#09047: Product Safety - Engine Compartment Fire - (Apr 14, 2009)

Subject: 09047 -- Engine Compartment Fire

Models: 1997-2003 Buick Regal
 1998-1999 Chevrolet Lumina
 1998-2003 Chevrolet Monte Carlo
 2000-2003 Chevrolet Impala
 1998-1999 Oldsmobile Intrigue
 1997-2003 Pontiac Grand Prix
 Equipped with 3.8L V6 Naturally Aspirated Engine (RPO L36 - VIN K)

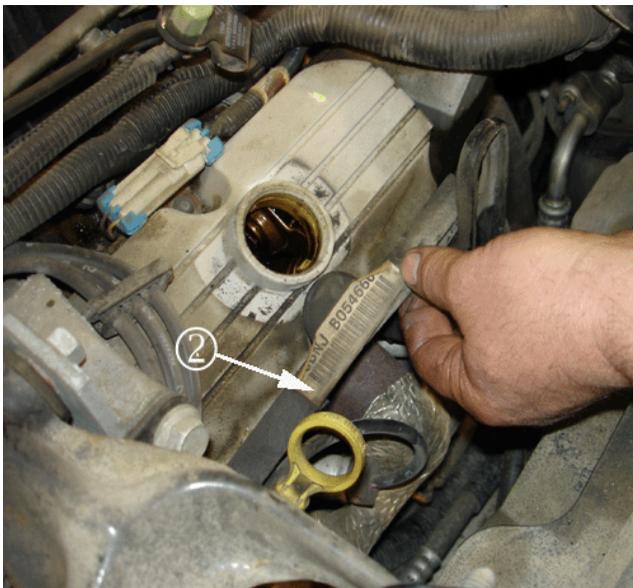
1. Remove the fuel injector sight shield (1). Refer to Fuel Injector Sight Shield Replacement in SI.

2. Remove the 1-3-5 spark plug plastic retaining channel (cover) clip/bracket (2) from the engine and discard it.

Dealers are to remove the 1-3-5 spark plug wire retention channel at the front of engine and replace it with new retainers.

7mm Four-Wire Retainer, P/N 88891792

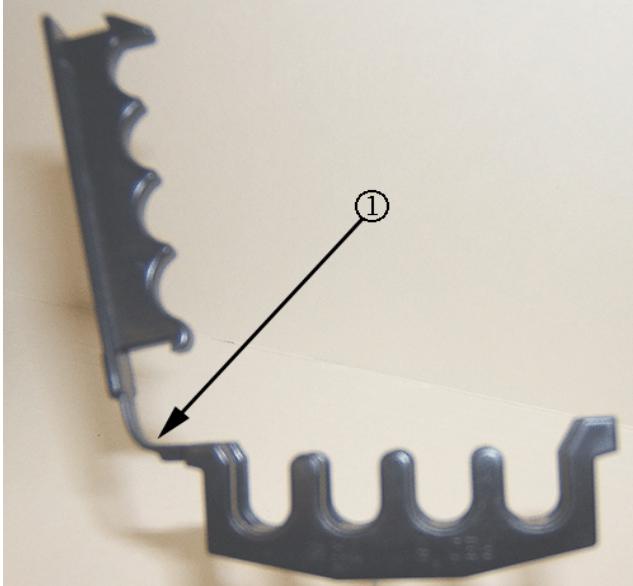
3. Install a 7mm four-wire retainer, P/N 88891792 (1) (qty 5/pack) to spark plug wire number 4, then to spark plug wires 1,3 and 5. Save the other 7mm or 8mm spark plug four-wire retainers for future repairs. Make sure that spark plug wires 2, 4 and 6 are secured to the original retainers and under the left engine mount strut bracket (2).

Important: If a 7mm four-wire retainer is not available, use an 8mm four-wire retainer (1), P/N 14066248 (qty 10/pack), or equivalent 7mm aftermarket spark plug wire retainer.

7mm Two-Wire Retainer, P/N 12132229

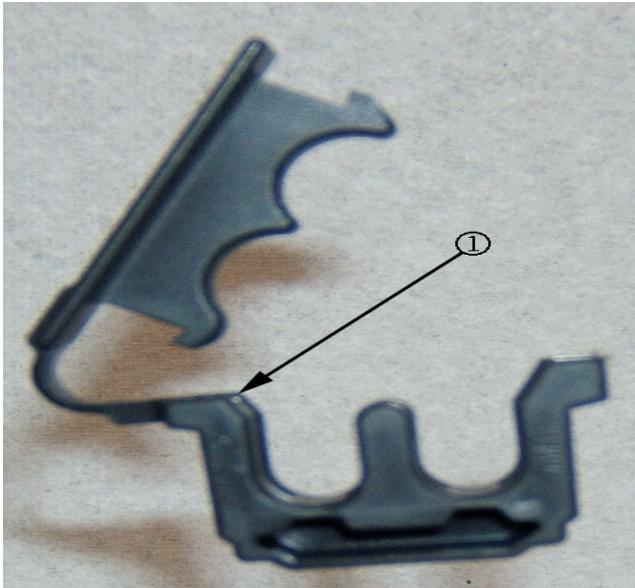
4. Install a 7mm two-wire retainer, P/N 12132229 (qty 10/pack) to spark plug wires 3 and 5 only (3). Save the other 7mm spark plug two-wire retainers for future repairs. Make sure the spark plug retainer (3) is approximately 50mm (2 in) from the oil level indicator (2).

Important: Ensure the installed spark plug wire retainers do not contact the fuel injector sight shield or exhaust manifold.
